SPECIAL TOWNSHIP BOARD MEETING
LOCATION: 7527 HIGHLAND ROAD, WHITE LAKE - ANNEX BOARD ROOM
TUESDAY, APRIL 22, 2025 – 5:00 PM

1. CALL TO ORDER
2. PLEDGE OF ALLEGIANCE
3. ROLL CALL
4. APPROVAL OF AGENDA
5. PUBLIC COMMENT
6. NEW BUSINESS
 - A. [REQUEST TO APPROVE CHANGE ORDER FOR UNDER FLOOR DRAINAGE SYSTEM - PUBLIC SAFETY BUILDING](#)
7. ADJOURNMENT

Bulletin #11

Date:	April 14, 2025
To:	Aaron Phillips		
Company:	McCarthy & Smith		
Project Name:	White Lake Township Public Safety Building Civic Center Development	Project No:	3702.00
		Phase No:	F07
Distribution:	White Lake Township McCarthy & Smith		
DOCUMENTS ISSUED WITH THIS BULLETIN:			
Documents: Drawings:			
Specifications: 06 20 13, 09 93 00			
This Bulletin forms part of the Contract Documents and modifies the original Bidding Documents dated June 03, 2024. Acknowledge receipt of this Bulletin in the space provided in the Bid Form. Failure to do so may subject Bidder to disqualification.

MD-1 Refer to Sheet M200 (Re-issued).

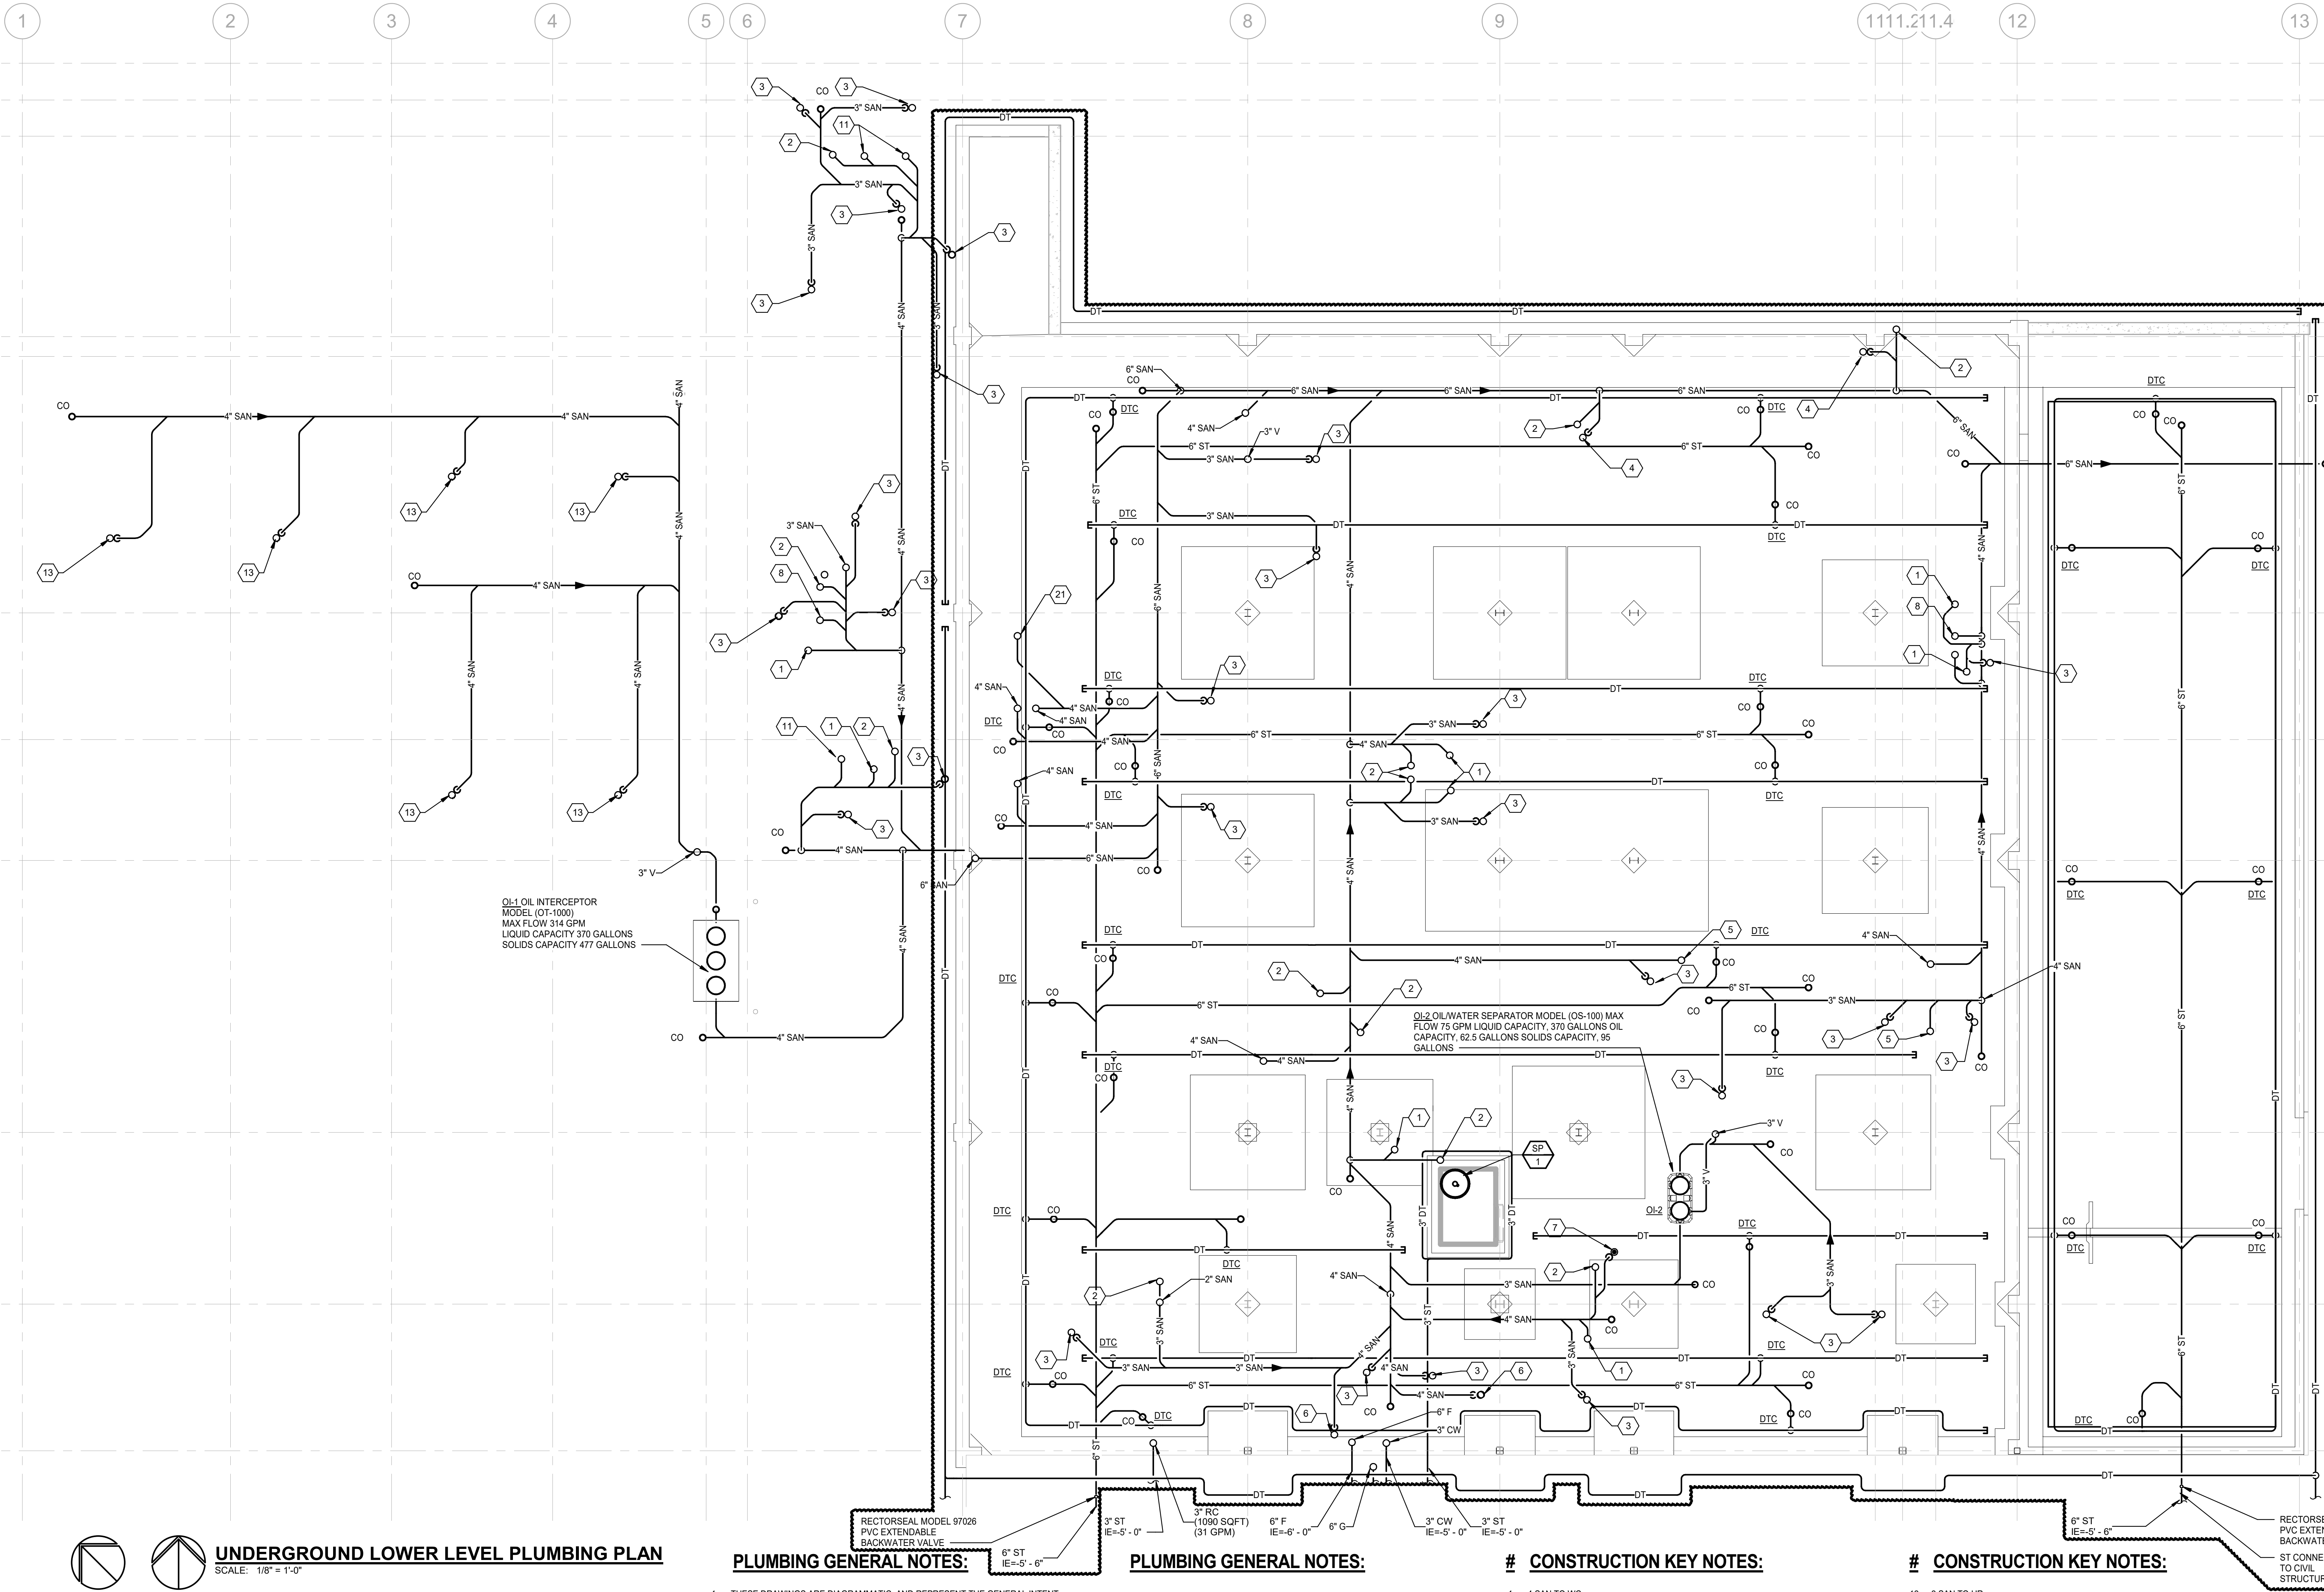
1. Revised underground subsoil drainage as indicated.

MD-2 Refer to Sheet M201 (Re-issued).

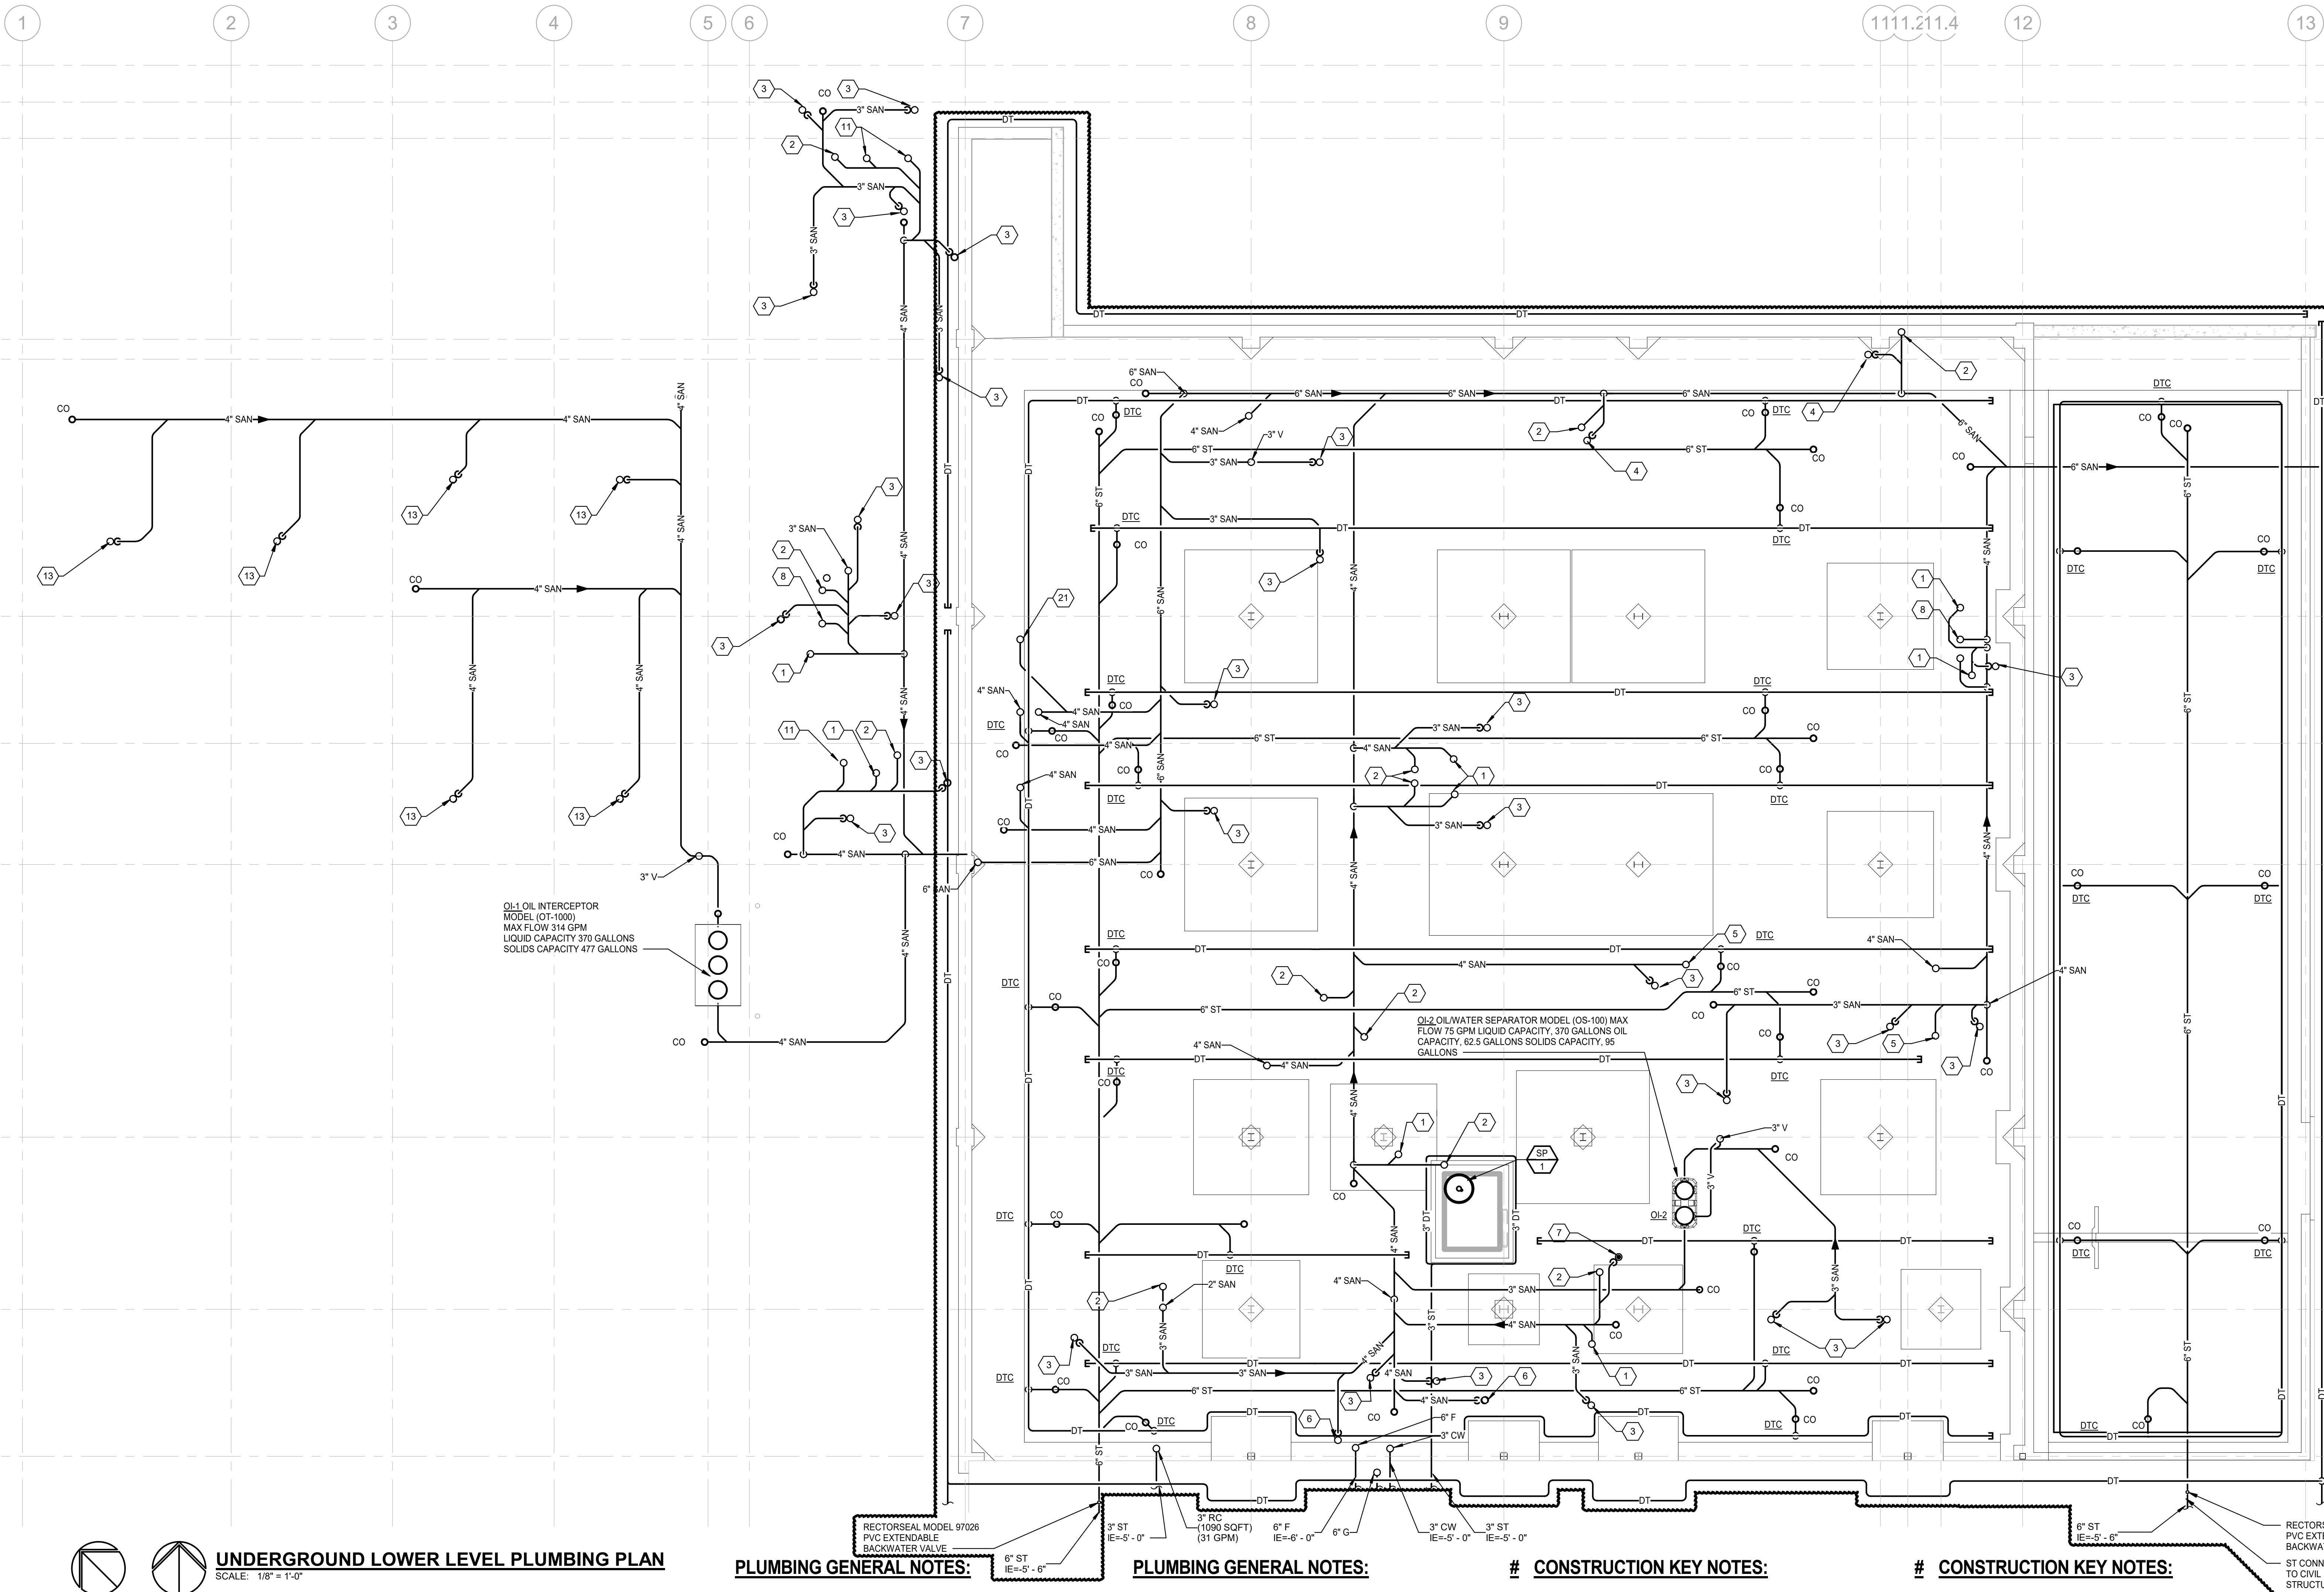
1. Revised CO's serving subsoil drainage as indicated.

C6.0 UTILITY PLAN (A)

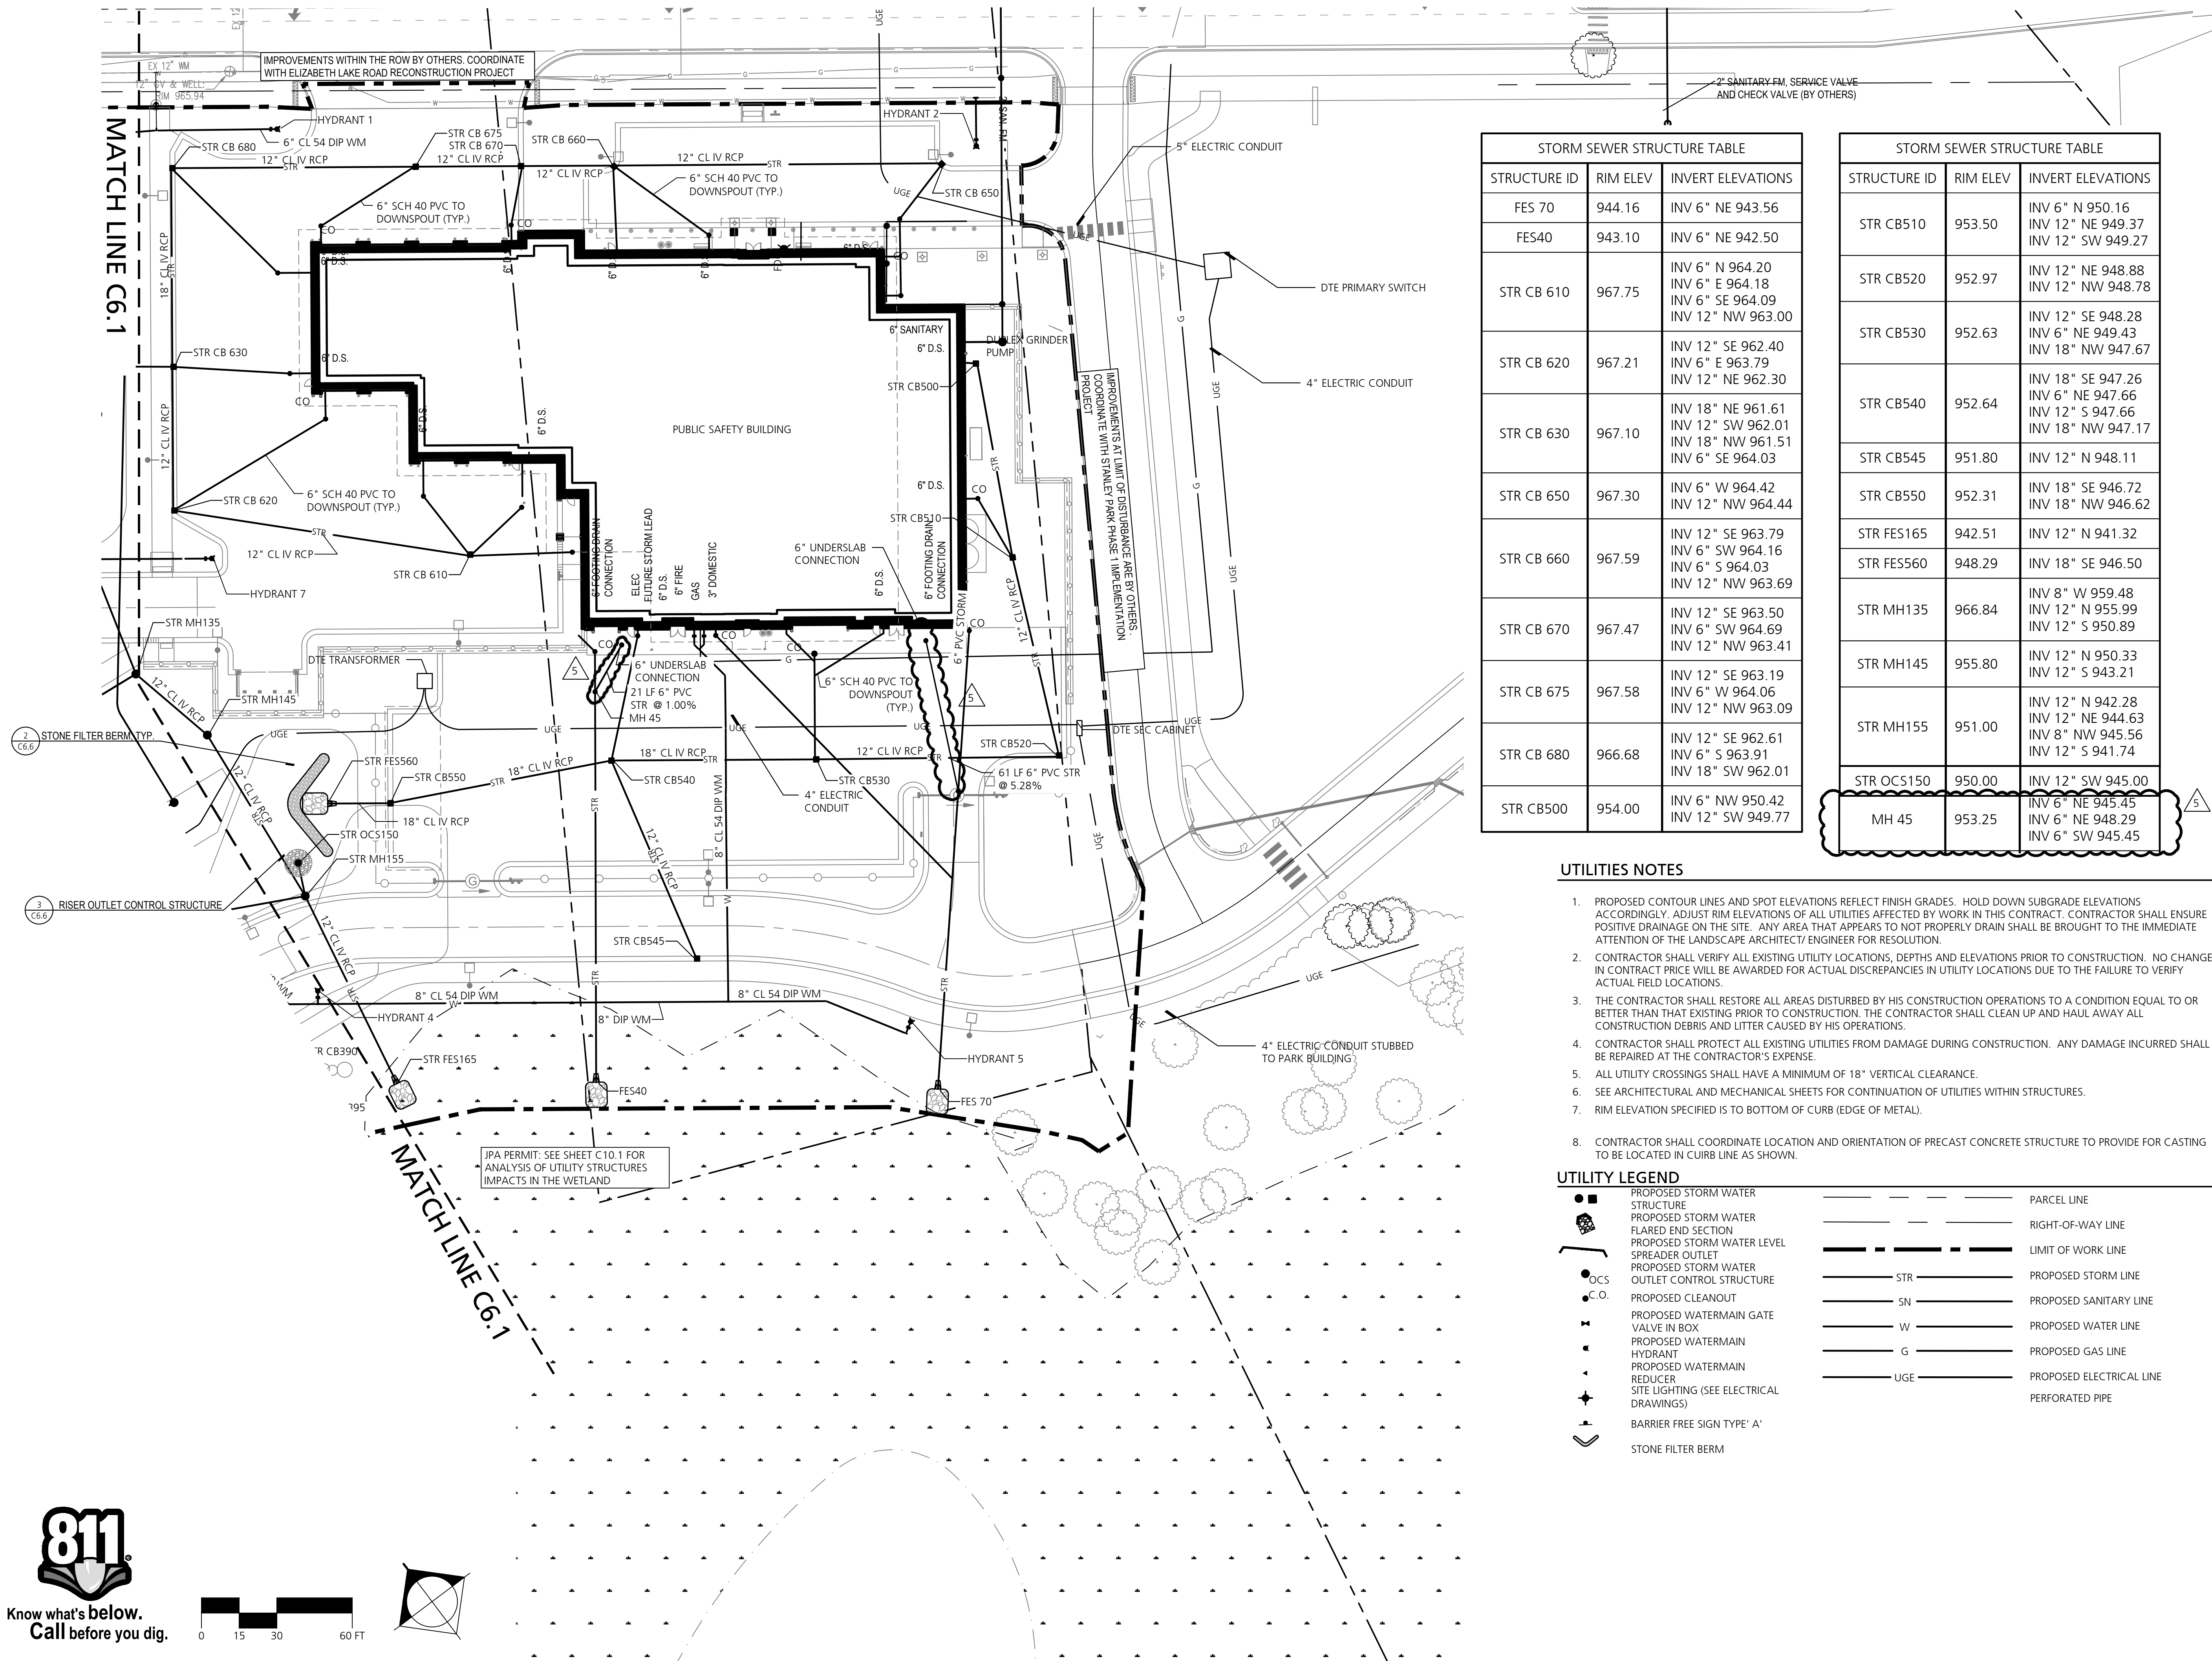
1. **C6.0 – Utility Plan (A)** (re-issued sheet)
 - a. Storm tie-in added for Public Safety Building underslab drainage system.
2. **C6.24 – Utility Plans & Profiles – Storm 8** (re-issued sheet)
 - a. Storm tie-in added for Public Safety Building underslab drainage system.
3. **C6.25 – Utility Plans & Profiles – Storm 9** (new sheet)
 - a. Storm tie-in added for Public Safety Building underslab drainage system.
